Product Change Notification: CAAN-04ALCQ551

CCB 8065 Final Notice: Qualification of palladium coated copper with gold flash (CuPdAu) as a new bond wire material and QMI519 as a new die attach material for selected MCP601, MCP603, MCP6041, MCP6043, MCP606, MCP608, MCP6141, MCP6143, MCP616, MCP6231, MCP6241, MCP6271, MCP6273, MCP6281, MCP6283, MCP6291, MCP6293, MCP6541, MCP6546, MCP6L1 and MCP6L71 device families available in 8L SOIC (.150in) package at MTAI assembly site.

Pre and Post Change Summary
PCN #: CAAN-04ALCQ551

Pre and Post Change Summary

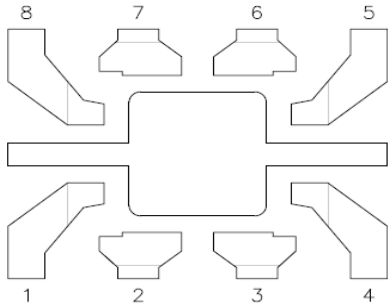
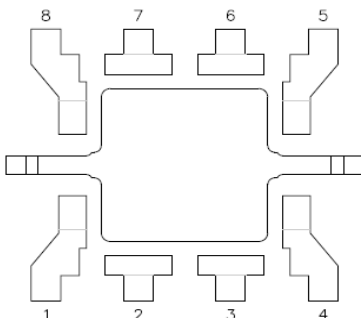
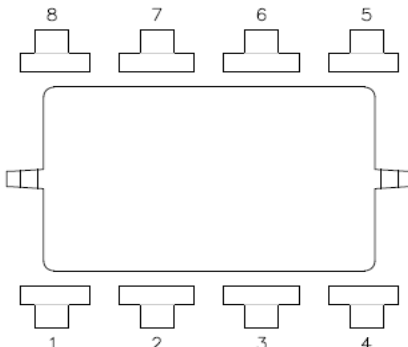
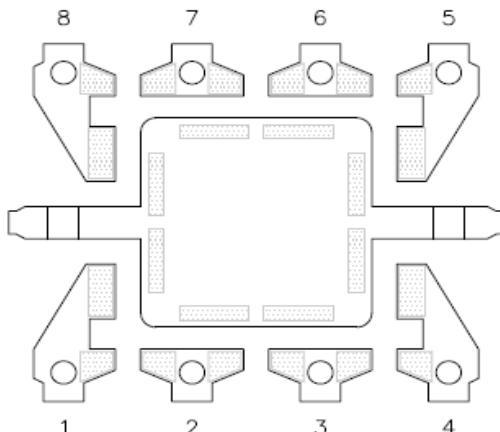
<table><tr><td>Lead-Frame Material</td><td>CDA194</td></tr><tr><td>Lead-Frame Paddle Size</td><td>60 x 60 mils</td></tr></table>	Lead-Frame Material	CDA194	Lead-Frame Paddle Size	60 x 60 mils	<table><tr><td>Lead-Frame Material</td><td>CDA194</td></tr><tr><td>Lead-Frame Paddle Size</td><td>90 x 90 mils</td></tr></table>	Lead-Frame Material	CDA194	Lead-Frame Paddle Size	90 x 90 mils	<table><tr><td>Lead-Frame Material</td><td>CDA194</td></tr><tr><td>Lead-Frame Paddle Size</td><td>95 x 158 mils</td></tr></table>	Lead-Frame Material	CDA194	Lead-Frame Paddle Size	95 x 158 mils	<table><tr><td>Lead-Frame Material</td><td>CDA194</td></tr><tr><td>DAP Surface Prep</td><td>90 x 90 mils</td></tr></table>	Lead-Frame Material	CDA194	DAP Surface Prep	90 x 90 mils
Lead-Frame Material	CDA194																		
Lead-Frame Paddle Size	60 x 60 mils																		
Lead-Frame Material	CDA194																		
Lead-Frame Paddle Size	90 x 90 mils

Lead-Frame Material	CDA194																		
Lead-Frame Paddle Size	95 x 158 mils																		
Lead-Frame Material	CDA194																		
DAP Surface Prep	90 x 90 mils
